901 Lenora

Recommendation Meeting

#3039979-LU

11/21/2023

Level 01 Floorplan | 9th Ave Landscaping

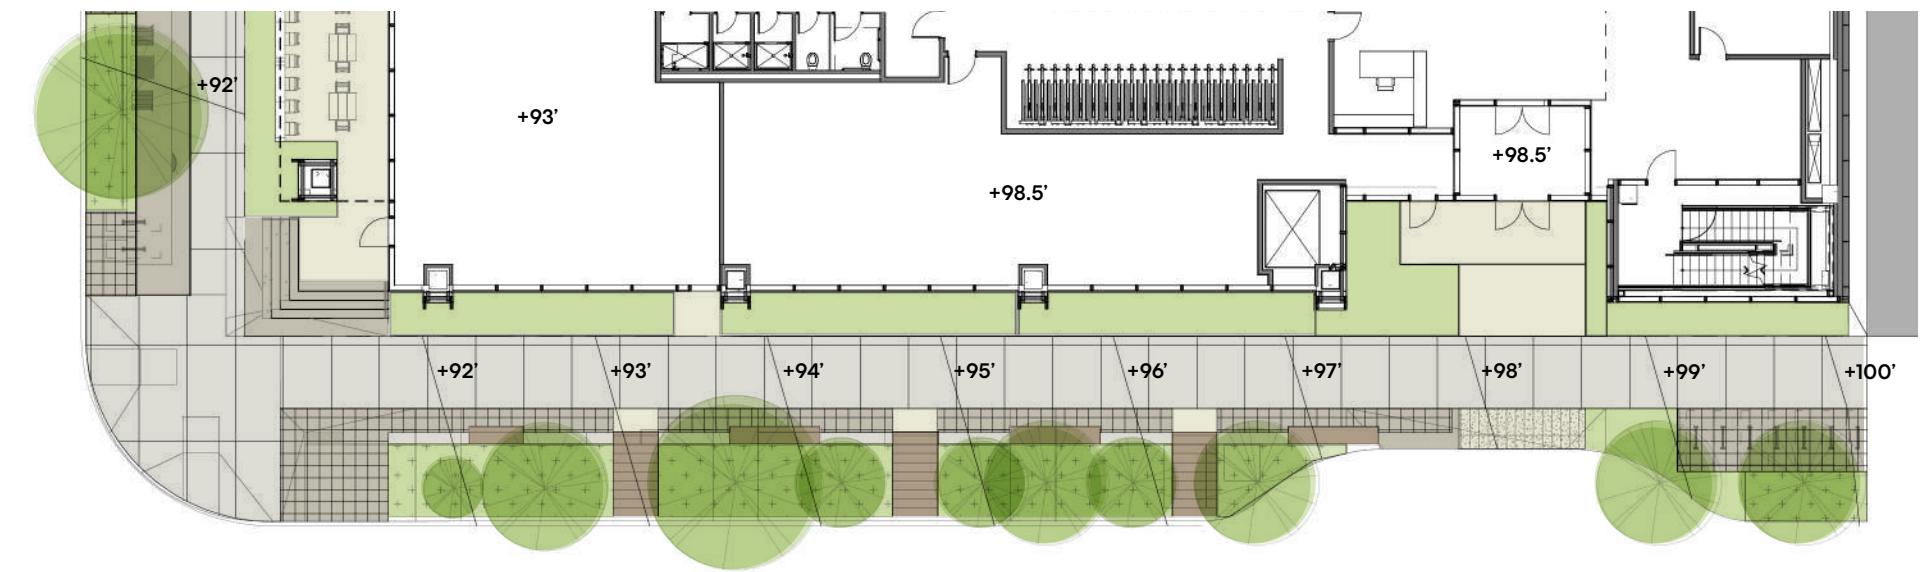
Staff is concerned by the **depth of the landscape planting bed adjacent to the commercial space along 9th Ave**, which doesn't support the commercial character or street activation. Revisit the configuration as shown at EDG which appeared more successful.

- In order to maintain accessible entries to the corner retail, cycling studio entry and main building entry, the ground floor level is split to accommodate the different required access elevations. Due to the significant slope along 9th, and in order to prioritize these other key entries it is challenging to provide additional entries along 9th Ave.

- The proposed landscaping also adds a significant additional depth (5') of landscaping to the 9th Ave green street, enhancing the character of the street while maintaining low planting to visually connect the interior program of the building to the street-scape.
